Corstorphine Connections – Phase 1 Stage 3 Road Safety Audit

City of Edinburgh Council

October 2023

Report Title:	Corstorphine Connections – Phase 1 Stage 3 Road Safety Audit
Date:	October 2023
Document Reference and Revision:	8003_701
Prepared by:	Atkins
Overseeing Organisation:	City of Edinburgh Council

Problem:	3.1
Location(s):	Featherhall Crescent - at Meadow Place Road
Drawing(s):	60636731-SHT- C-P1-LTN-0701
Summary:	Evidence of surface water collection at pocket park.

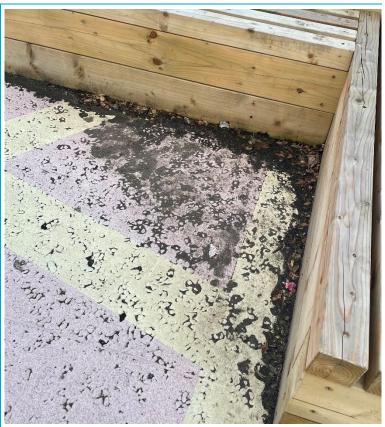
Residual debris observed during the site visit indicates surface water collection at the pocket park on Featherhall Crescent. Surface water presents a slip and fall hazard to pedestrians and cyclists, particularly during periods of cold freezing weather when water can form ice.

It is recommended that positive drainage is provided.

3.1	Evidence of surface water collection at pocket park	positive (mended that drainage is vided.	accepted - remedy dra	noted and Contractor to sinage through p holes	Agree with designer		As per designer response
